WE HAVE REPLACED

2ND STAGE SUCTION AND DISCHARGE VALVES
FOR PUMPING UNITS MCH 8 / 11 / 13 / 16 / 18
WITH NEW ONES.

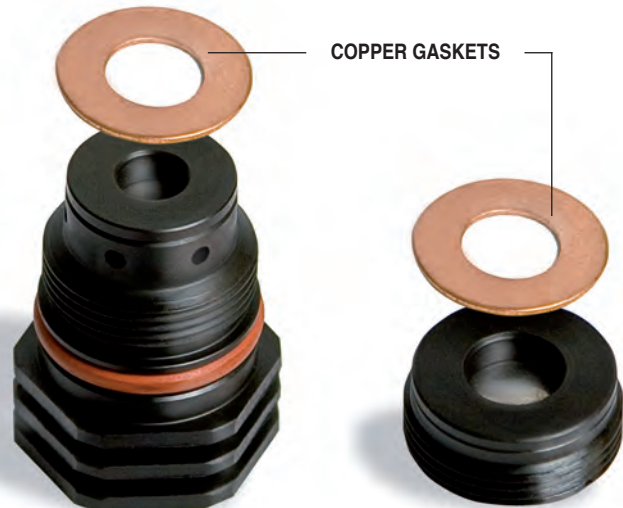
- BETTER SEAL THANKS TO THE VITON O-RING
- BETTER DURATION IN TIME
- LESS MAINTENANCE

**TOTALLY
INTERCHANGEABLE WITH
COPPER GASKET VALVES
NON LONGER
IN PRODUCTION.**

NEW DISCHARGE VALVE
2nd STAGE
CODE 13-02-0049/R

SEAL O-RING

NEW SUCTION VALVE
2nd STAGE
CODE 13-02-0044/R
